UNITED STATES
NUCLEAR REGULATORY COMMISSION
WASHINGTON, D. C. 20555

APPLICANT: Public Service Electric & Gas Company (PSE&G)
FACILITY: Hope Creek Generating Station
SUBJECT: SUMMARY OF STRUCTURAL AND GEOTECHNICAL ENGINEERING
BRANCH (SGEB) MEETING

On August 1, 1984, a meeting was held in the Bethesda, Maryland offices of the NRC to discuss the remaining SGEB-Structural audit open items identified in the Draft SER. A list of meeting attendees is included as Enclosure 1 to this meeting summary.

FIGURE A-13-8

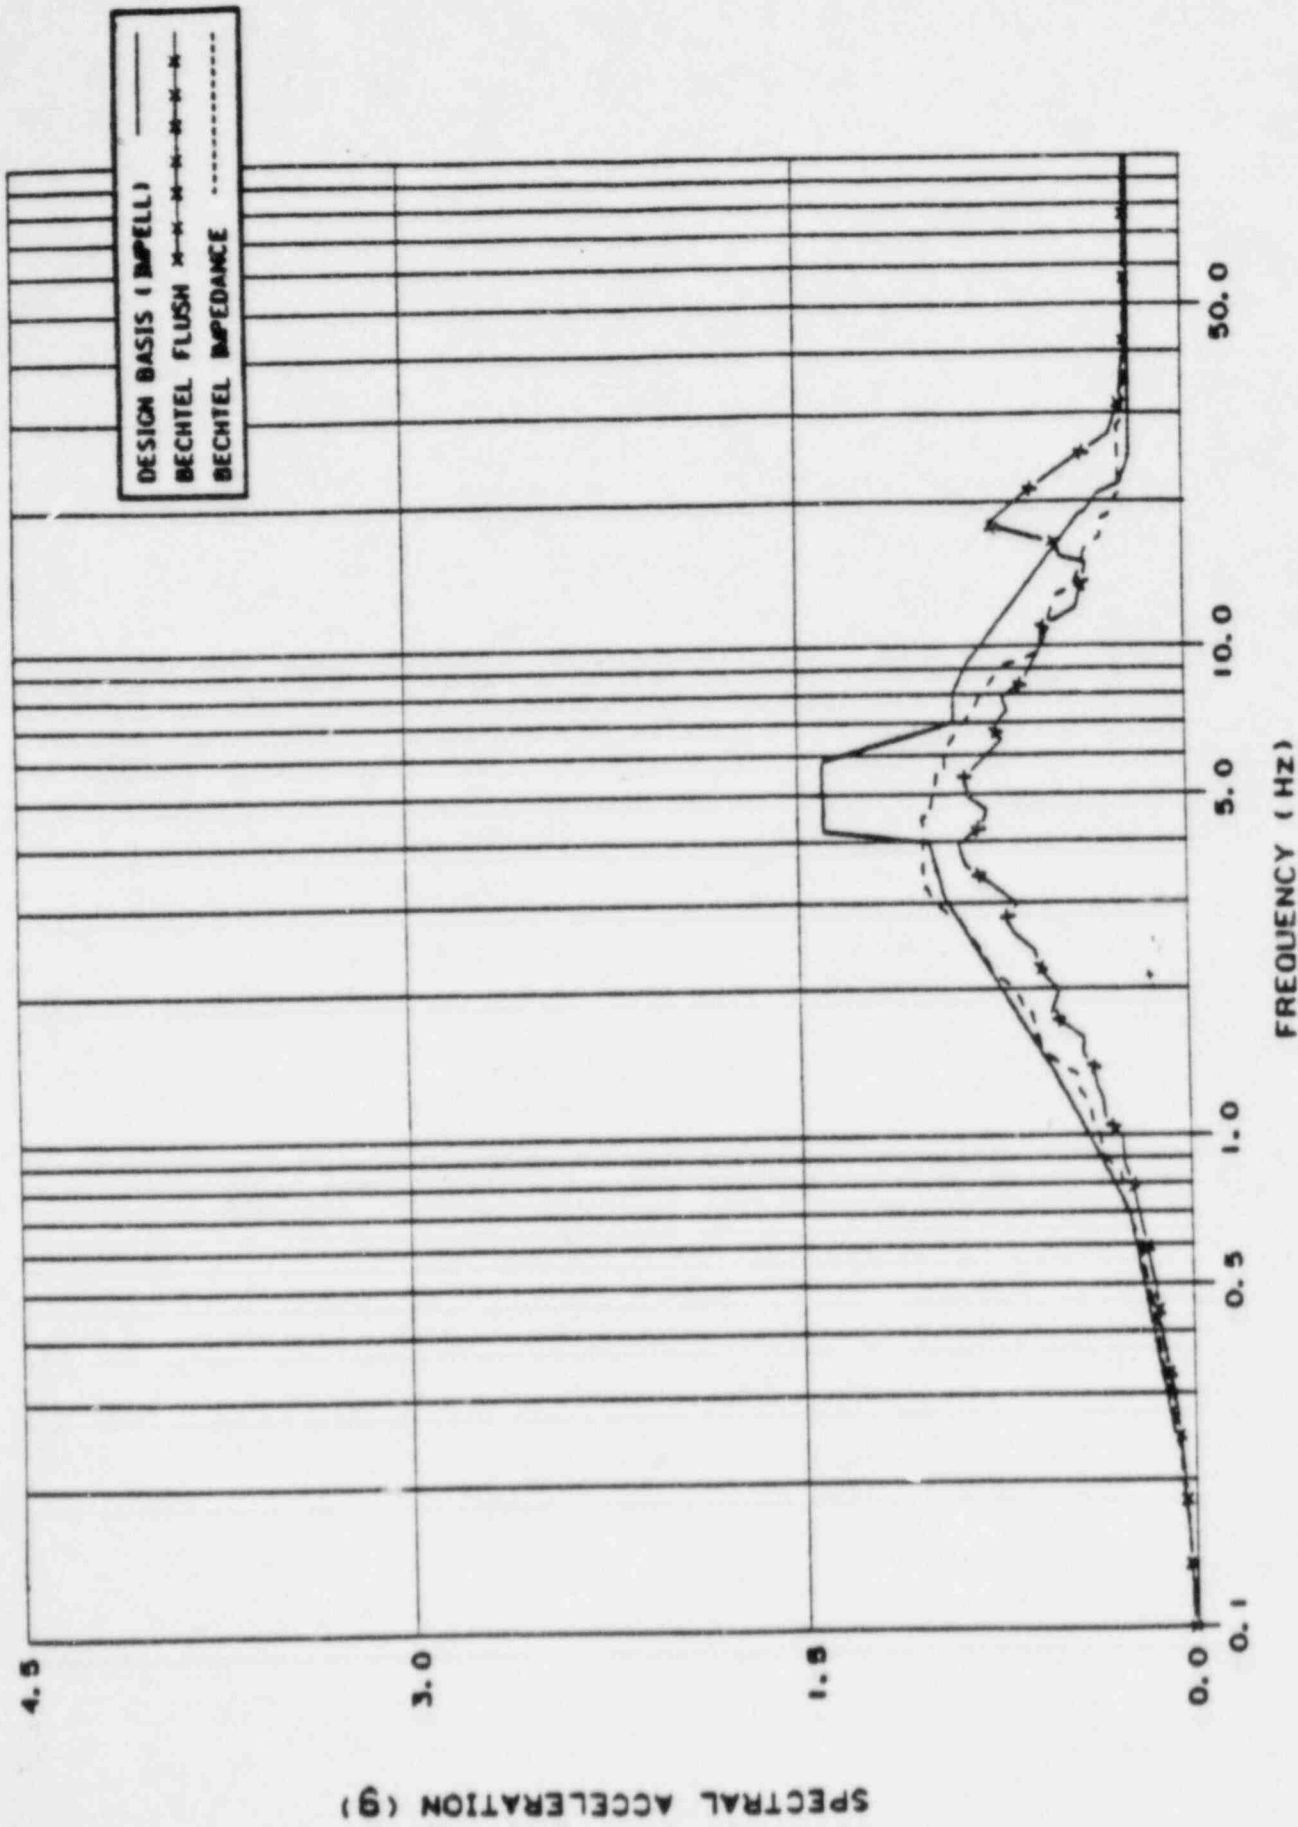
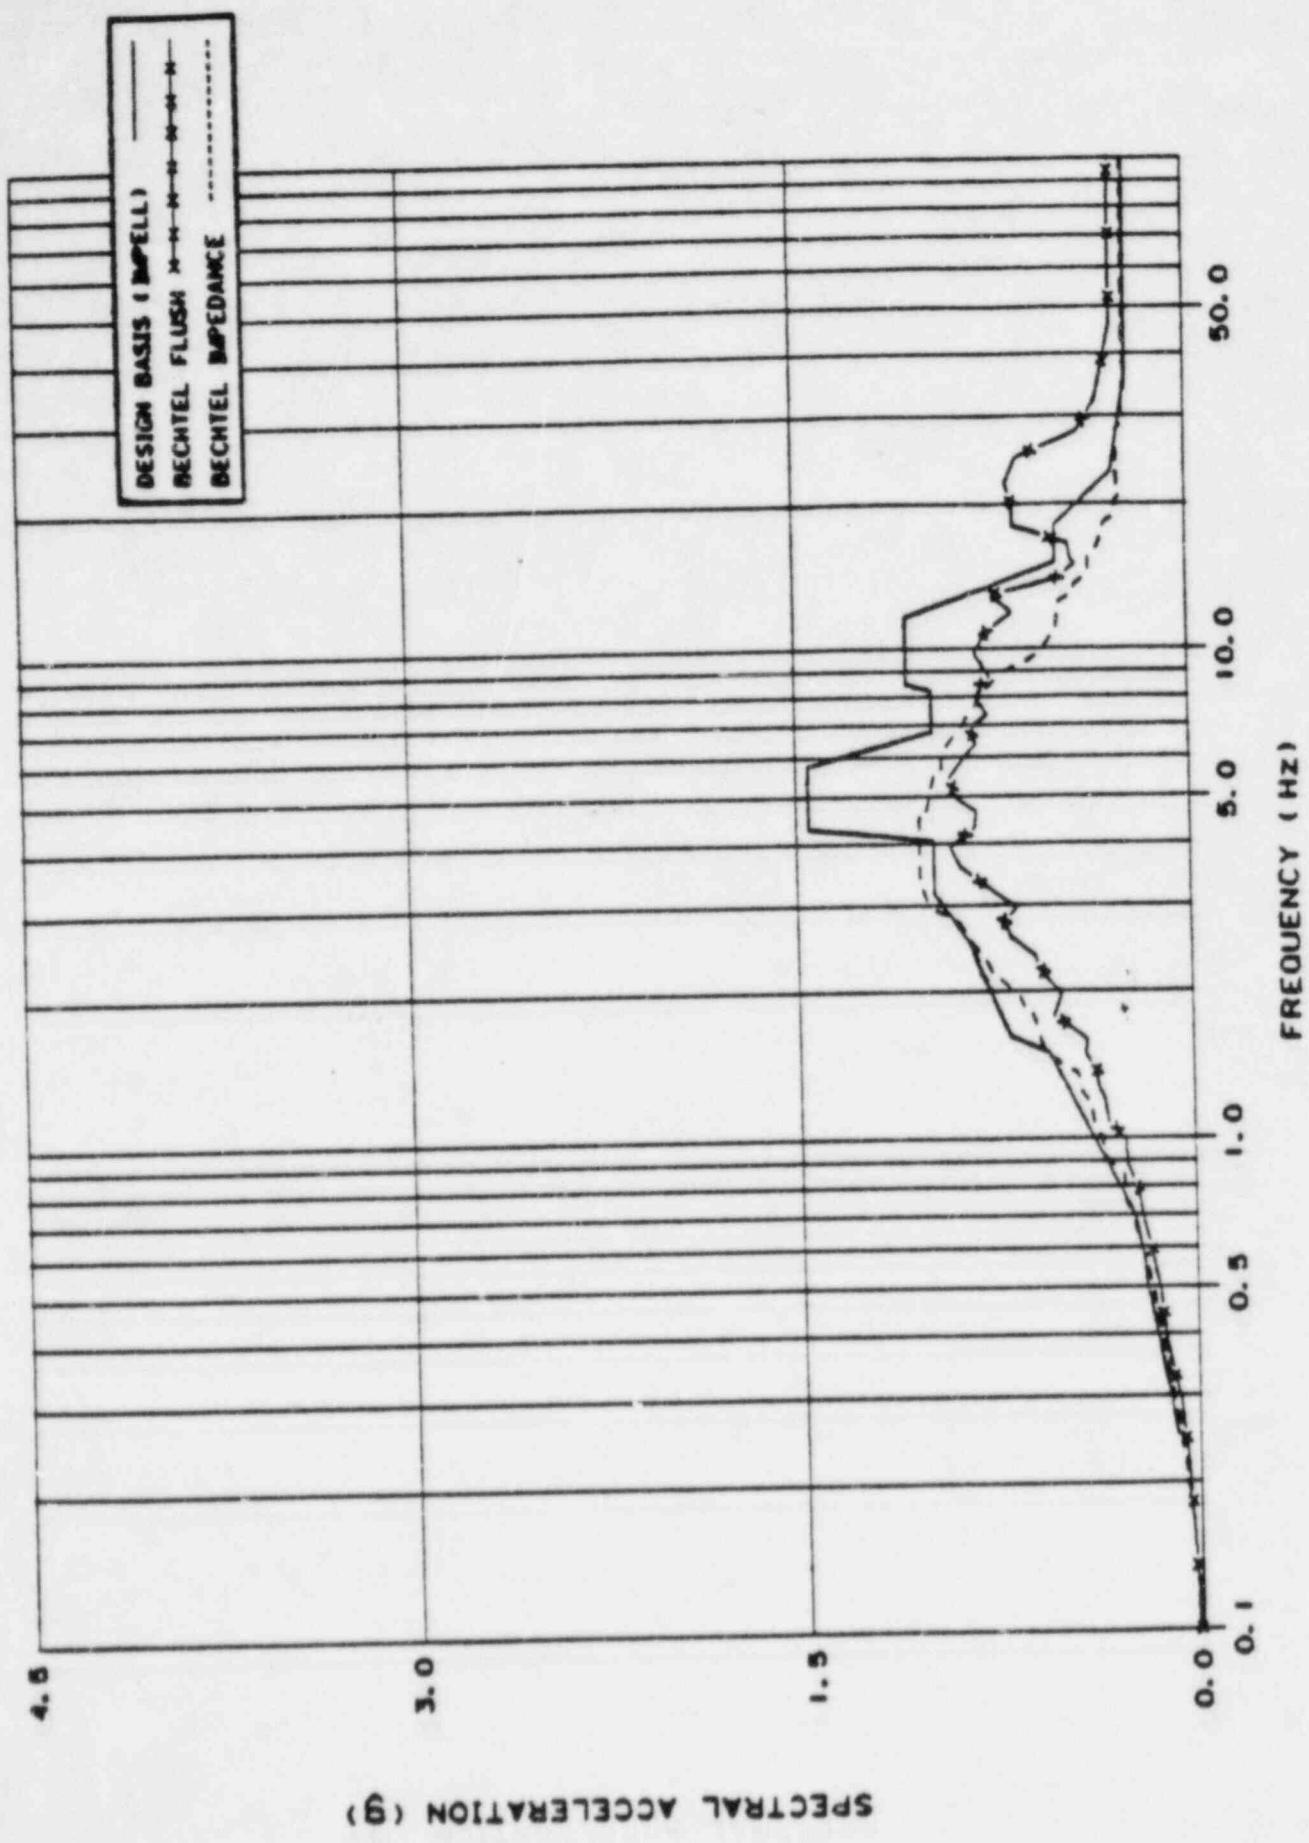
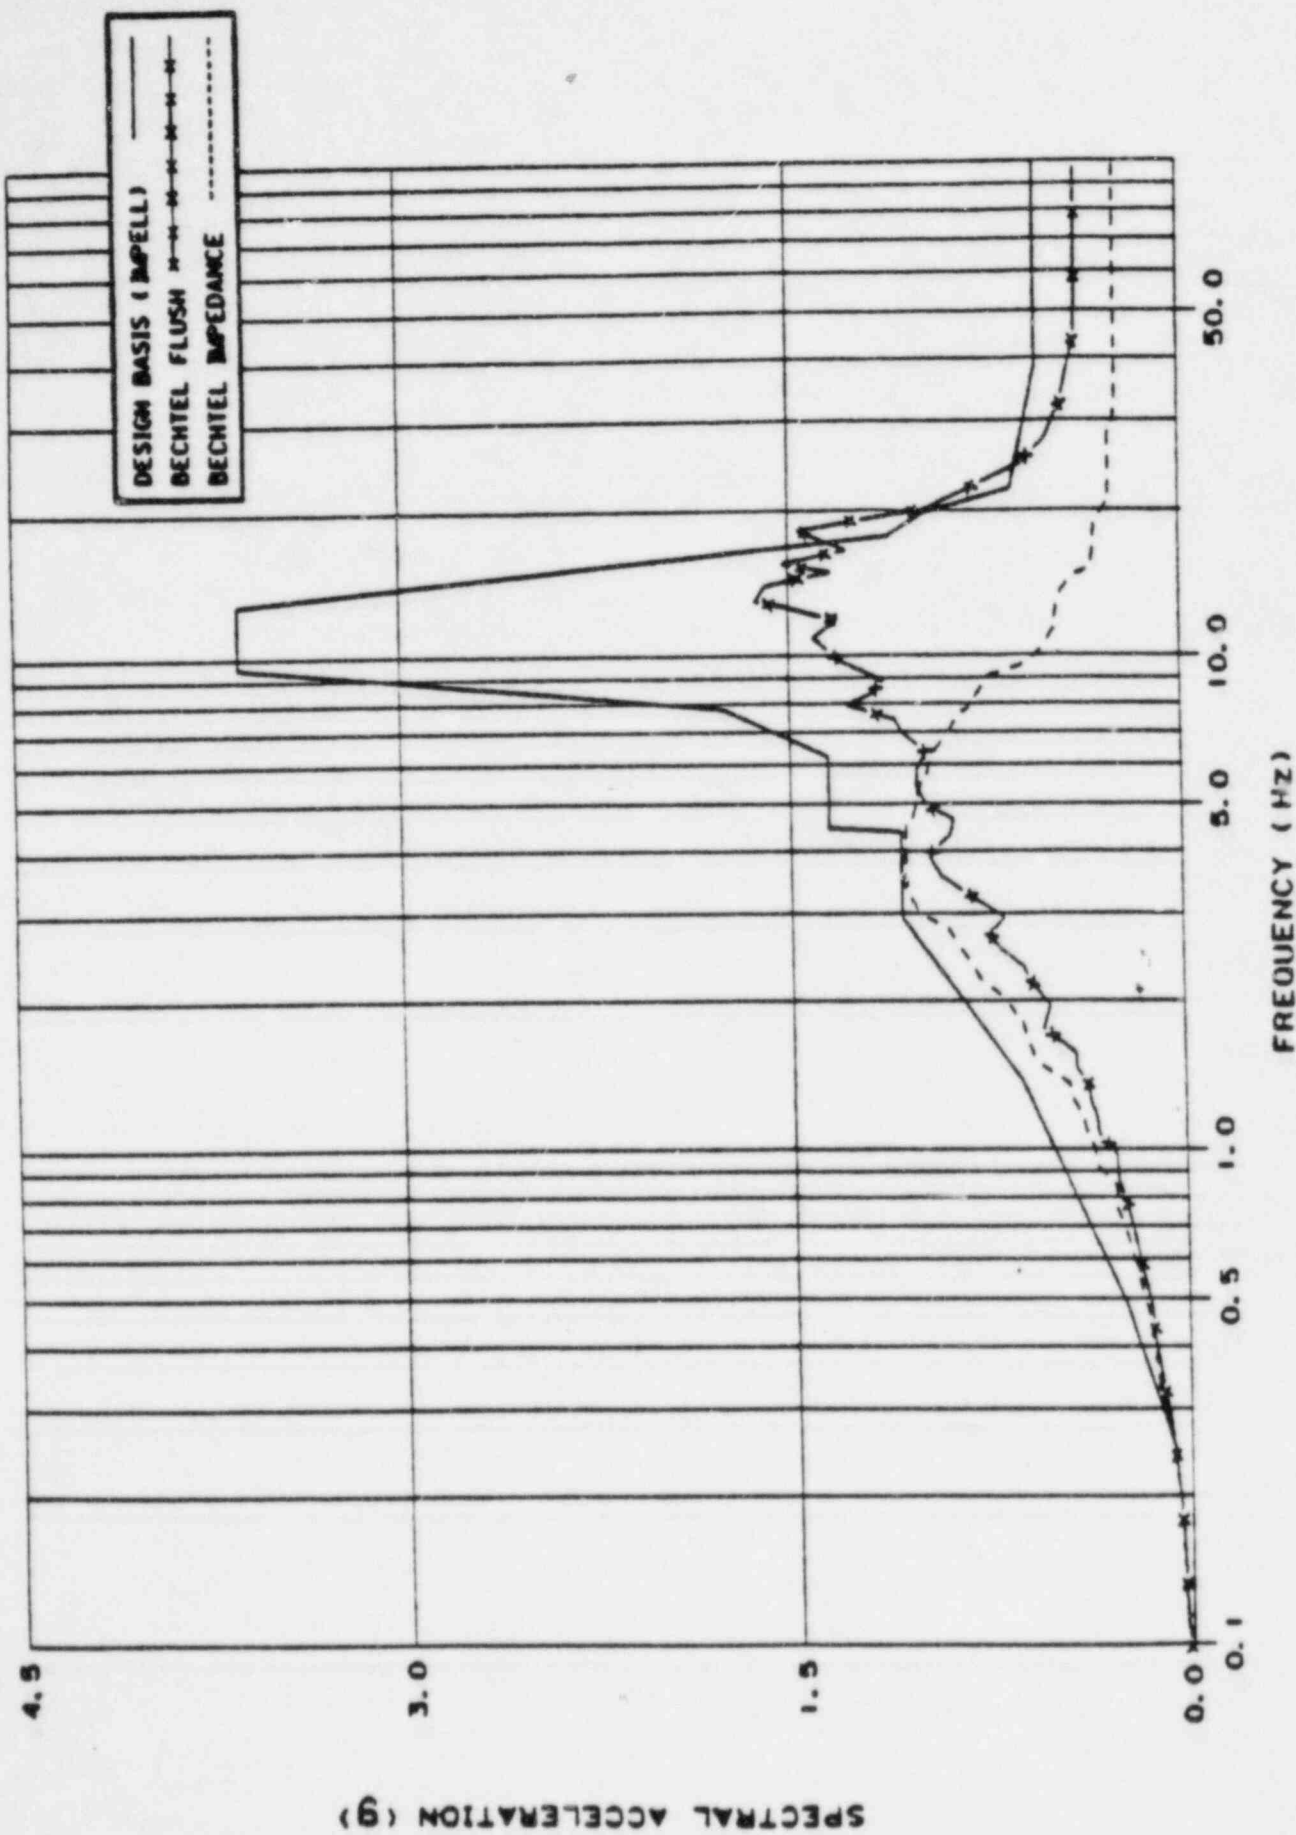
Question: Provide comparison of Bechtel Independent Verification Results with the Design Basis Results.

Figures A-13-2 to A-13-37 show the comparison of the response spectra (2% damping) obtained from the above three seismic soil-structure interaction analyses. Discussions of these comparisons are as follows:

Bechtel's independent soil-structure interaction analyses are performed using the computer code FLUSH. The results of independent finite element analyses are in reasonable agreement with those of the design basis analyses. As can be seen from Figures A-13-2 through A-13-37, the horizontal response spectra obtained from the independent finite element analyses are generally enveloped by those obtained from the design basis analyses except for the frequency range lower than 2 Hz. The vertical response spectra showed some exceedances at the frequency range of 18 Hz. These exceedances are listed in Table A-13-1.

The peak spectral accelerations obtained from the impedance approach analyses are generally lower than those obtained from the design basis analyses. However, these response spectra are not completely enveloped by those obtained from the design basis analysis, especially in the frequency range between 1.0 and 3.5 Hz. Also, there are some local exceedances in the higher frequency range, as shown in Figures A-13-2 through A-13-37.
